HORSHAM DISTRICT COUNCIL CONSULTATION

REFERENCE:	DC/25/1312
RECOMMENDATION:	Advice / More Information / Modification
SUMMARY OF COMMENTS & RECOMMENDATION:	
Please note this is an interim response and further comments will follow once the remaining information/documents have been reviewed. Comments at this stage relate to the documents listed below, although where needed, other documents have been cross-referenced against these to fully understand the proposals:	
<ul style="list-style-type: none">• Development Specification & Parameter Plan Framework• ES Chapter 11 – Landscape and Visual (and associated appendixes) – separate response to follow on this• Design and Access Statement (more comments likely to follow at a later stage)• Phase 1 Landscape & Ecological Management Plan

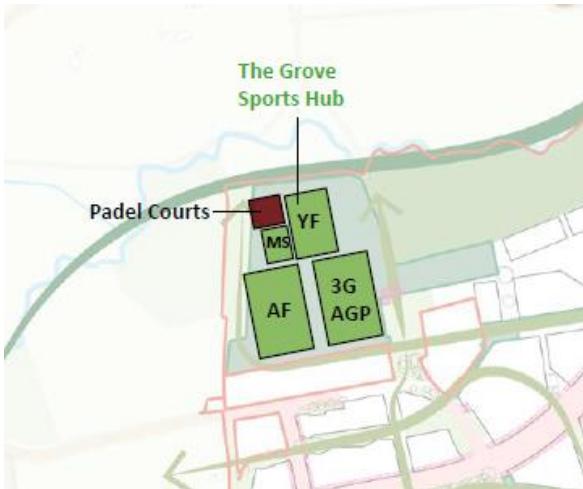
8. Parameter Plan 4 – Building heights – please clarify why vast areas that are to remain undeveloped as open green space are shown as within the 6m building height above existing levels dashed blue light area. We recommend this is removed or tightened to only include sports fencing areas and any associated buildings (such as club house)

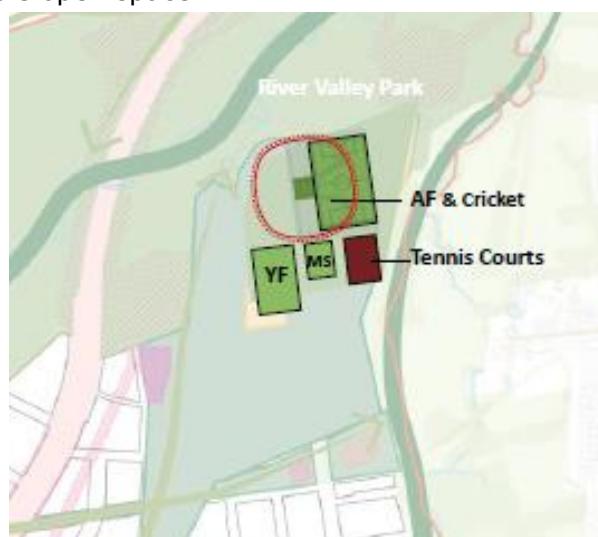
10. It is noted at page 83 that Padel courts are indicatively shown within the sports hub (see extract below on the left). We have concerns with the uncoordinated nature of the information provided within the various bundles as various concepts are being overlapped without due consideration and with conflicting objectives. For example, padel sports provision is indicated within The Grove, however the same area is shown as an attenuation basin (see page 111 - no 14) as shown on the extract below. The stakeholders looking at

sport provision are unlikely to look at the drainage strategy and vice versa risking the acceptance of both strategies which clearly cannot be delivered in tandem. Given the constraint nature of the site and formal nature of the sports provision with standard dimensions, a suitable location must be demonstrated within the indicative masterplan.

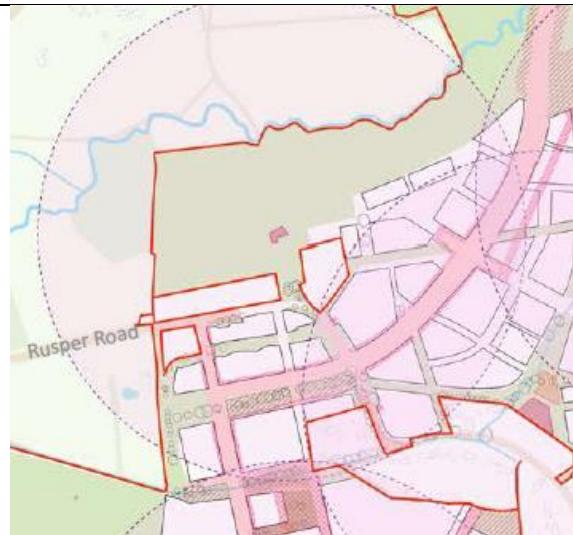
12. Page 116 – Play provision – Please note youth areas and facilities section needs to be expanded to include gender inclusive provision such as sheltered seating, bespoke muga's that are multifunctional and not fenced off on all boundaries, etc.

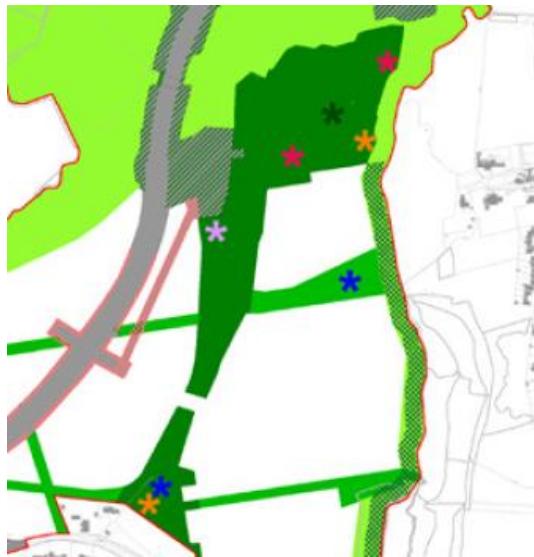
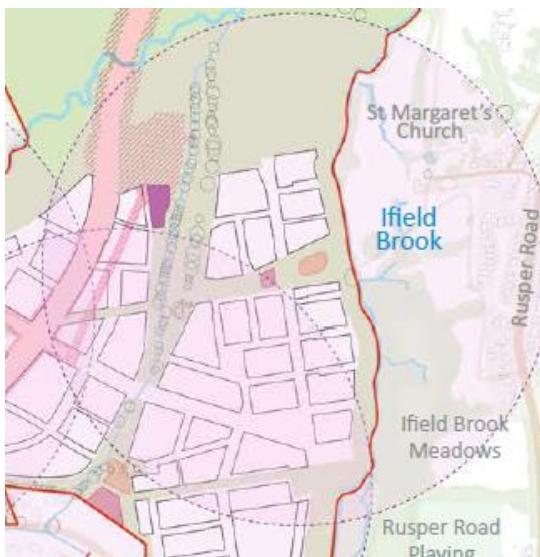
14. The open space indicated below as a potential LEAP location, is considered ideal for informal recreation such as '*kick about space, picnicking, kite flying*' under the amenity greenspace definition. The minimum space requirement for this typology is 0.05ha, with a 80% hard wearing own grass. We recommend the play location within the parameter plan is moved towards the area indicated as 'youth areas and facilities' within the diagram in the DAS. As discussed previously under the parameter plan section, the buffer zones associated with each typology (i.e 20m for a LEAP) must be indicated within the diagrams to demonstrate that sufficient space is allowed within the parameter plans (landscape and land use) to meet the requirements.
